LEN23026

RE: Rolesville Crossing
Case Number: SDP-24-06
Response to 2nd SDP Comments
LEN23026

C3.00 Amenity Grading, Drainage, and Erosion Control Plan

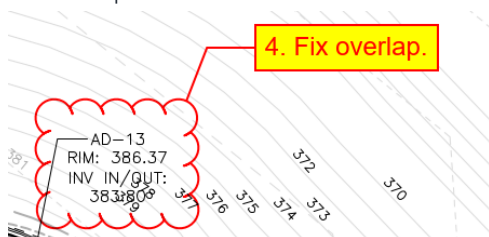
3. There should be one set of existing topo and it should match the existing conditions sheet. Please freeze any other "existing" topo on this sheet.

4. Based on the proposed AD rim elevations versus the existing grades within the footprint of the amenity center, a significant amount of fill will be required on the high end of the retaining wall. In addition, one of your comment responses says "top of wall elevations will be modified under the cover". Please show proposed grading and/or proposed retaining wall top and bottom elevations. These were shown in the first submittal.

McAdams Response: Understood, the mass grading approved with the subdivision are shown throughout as existing grade.

McAdams Response:
